WAKE COUNTY DEPARTMENT OF ENVIRONMENTAL SERVICES WELL AND SEWAGE SITE LOCATION PERMIT
NO PERMIT(S) FOR CONSTRUCTION, LOCATION OR RELOCATION ACTIVITY SHALL BE ISSUED
UNTIL AN AUTHORIZATION FOR WASTEWATER SYSTEM CONSTRUCTION HAS BEEN ISSUED
PERMIT VOID IF NOT IN COMPLIANCE WITH ZONING REGULATIONS AND/ OR IF SITE IS ALTERED OR INTENDED USE CHANGED

CASI Fe Plan Part B
 PIN#0628104804315
 D40120 3309 Avent Ferry Rd

SUBJECT: Septic System for William Mitchell Property Submitted for Review and Approval

LOW PRESSURE PIPE (LPP) DESIGN

Primary System

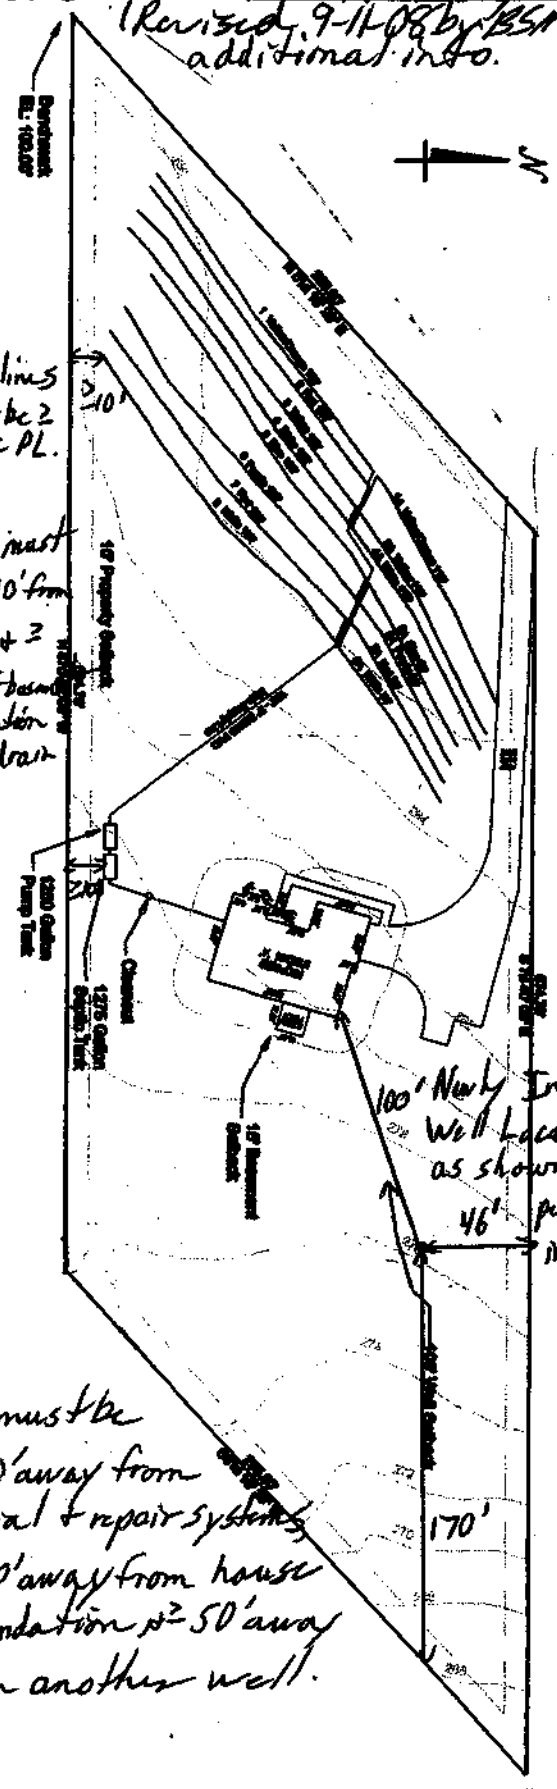
Drainlines must be $\geq 10'$ off PL.

Tanks must be $\geq 10'$ from PL, + $\geq 15'$ off basement/foundation drain

Overall Plan

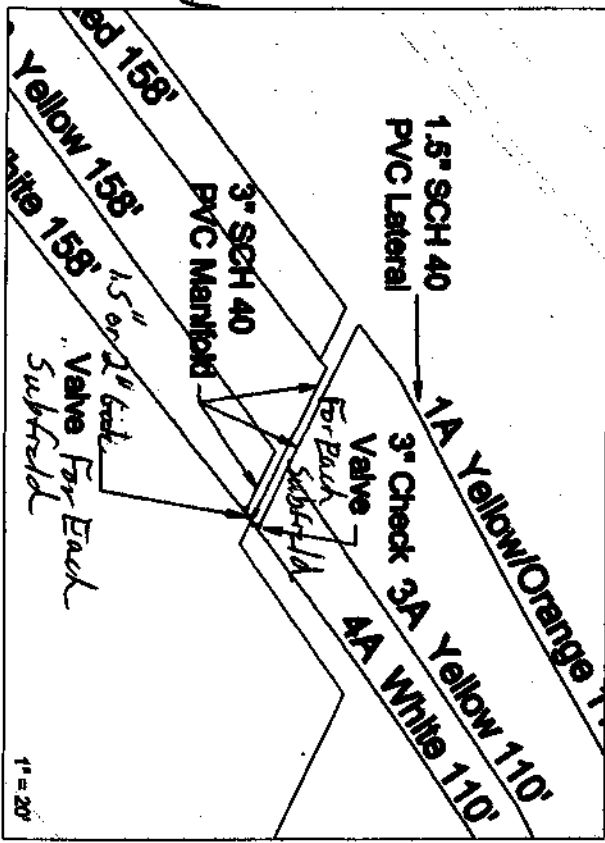
Well must be $\geq 100'$ away from initial & repair systems, $\geq 50'$ away from house foundation & $\geq 50'$ away from another well.
